# CUSTOMER ADVISORY

## ADV2002

### Label Content Update for FPGA and Power Products

**Table 2: Label Sample with “RoHS COMPLIANT”**

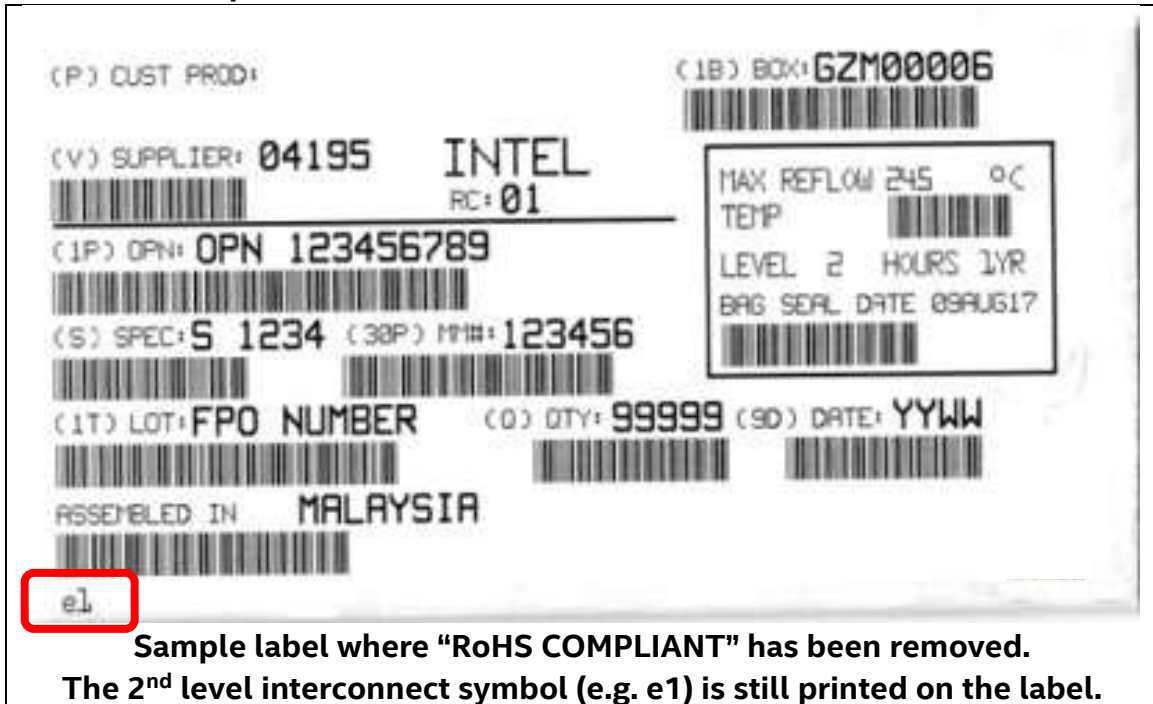
The label content change is to prevent displaying an inaccurate status of compliance to the EU Restriction of Hazardous Substances (RoHS) Directive during transition period due to the RoHS Exemption 15 scope change in February 29, 2020.

| Change From                                                       | Change To                                                                                                                                                       |
|-------------------------------------------------------------------|-----------------------------------------------------------------------------------------------------------------------------------------------------------------|
| "RoHS COMPLIANT" indicated on the lower left of the barcode label | Labels may or may not indicate " <b>RoHS COMPLIANT</b> " on the barcode label.<br><br>The 2nd level interconnect symbol (e.g. e1) remains printed on the label. |
